Fine Adjustment

In order that the watchmaker's tasks of regulating the movement and adapting it to the requirements of the individual may be facilitated as far as possible, TISSOT is introducing in sizes 781 to 784, together with the mobile stud holder described in Technical Service Bulletin No 29, a FINE ADJUSTMENT DEVICE. Below is a cross-section of this device.

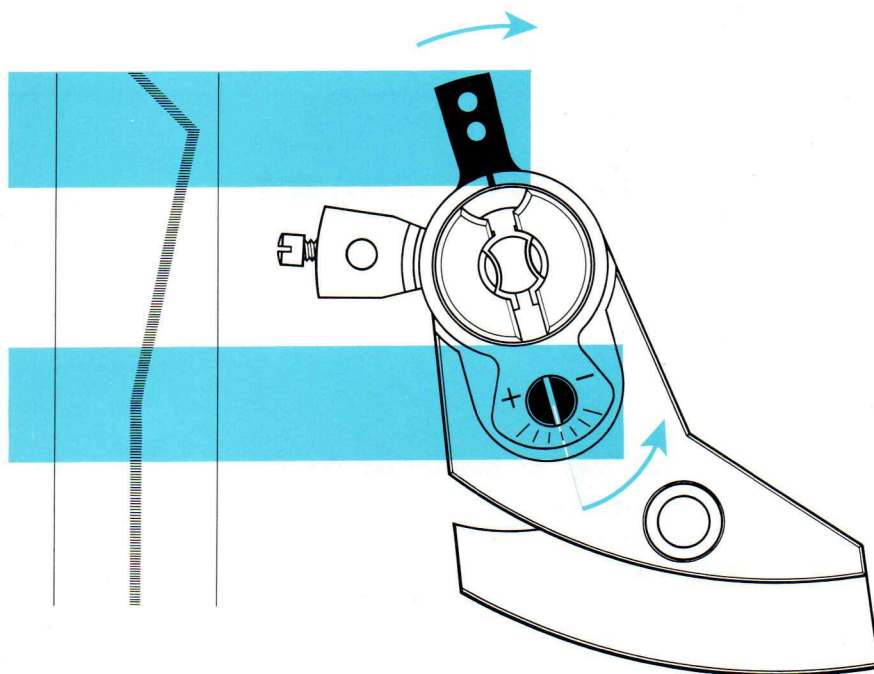
The modified components comprised in this assembly are indexed as follows:

- | | |

| 121/5 | Balance cock regulating device |
| 309/2 | Two-piece regulator adjusting device with fixed curb-pins |
| 324/1 | "Incabloc", upper driven in |
| 358 | Adjuster for regulator |
| 364 | Stud holder. |

The FINE ADJUSTMENT DEVICE is incorporated in movements bearing the following numbers upwards:

<u>Caliber 781</u>	: No 6 238 000
<u>Caliber 782</u>	: No 6 268 000
<u>Caliber 783</u>	: No 6 214 000
<u>Caliber 784</u>	: No 6 164 000
